STATE OF MAINE  
DEPARTMENT OF TRANSPORTATION  
16 STATE HOUSE STATION  
AUGUSTA, MAINE 04333-0016

July 30, 2025  
Subject: Woodland Fish Passage  
WIN: PH20250514WFP  
Location: **Baileysville**  
**Amendment No. 11**

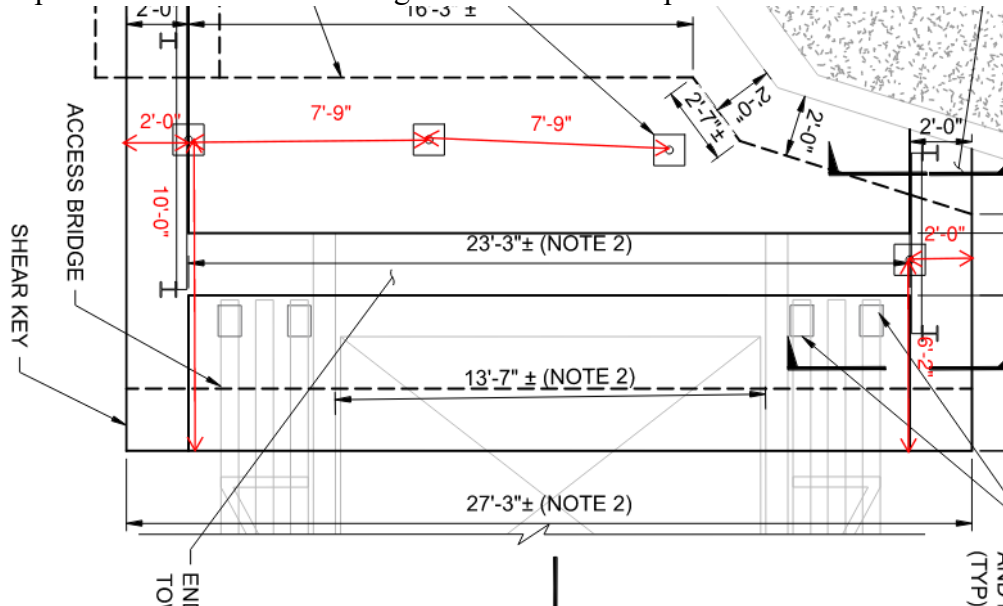
126. Question: On Sheet S-180, Access Bridge Abutment 1 Plan detail, please indicate the location of the rock anchors in plan view that are shown on detail D Sheet S-181. Plan view location of these will be necessary for layout.

Response: Refer to the following dimensional markups:

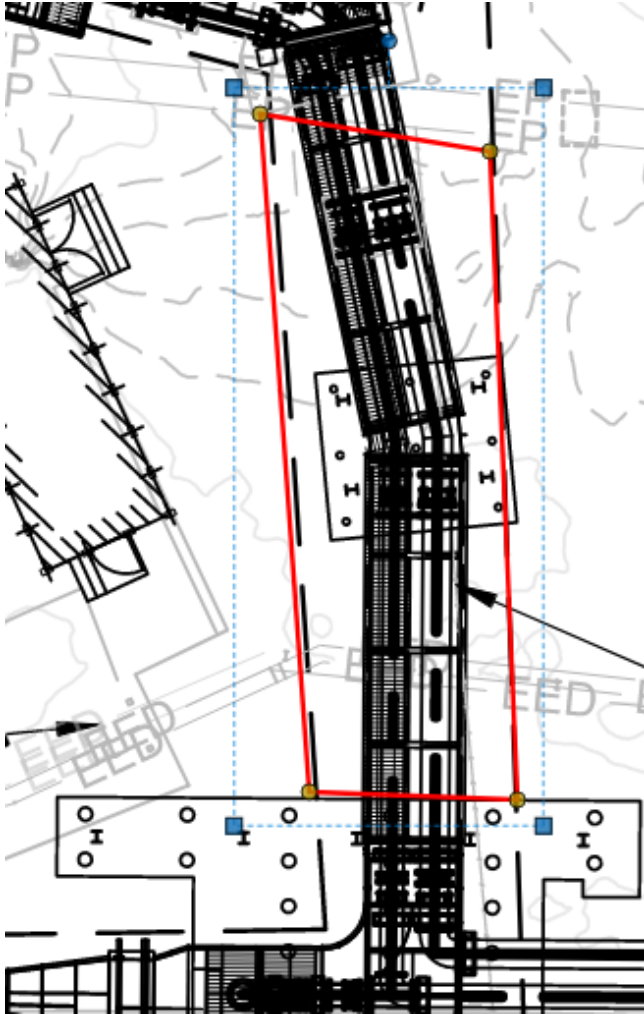
164. Question: Detail F on drawing S-404 shows a platform with stairs but no location is indicated. Please provide a detail that shows where this needs to be installed.

Response: Detail F is to provide a cross over for the piping. It can be located anywhere under the steel exit flume. See below for potential area.
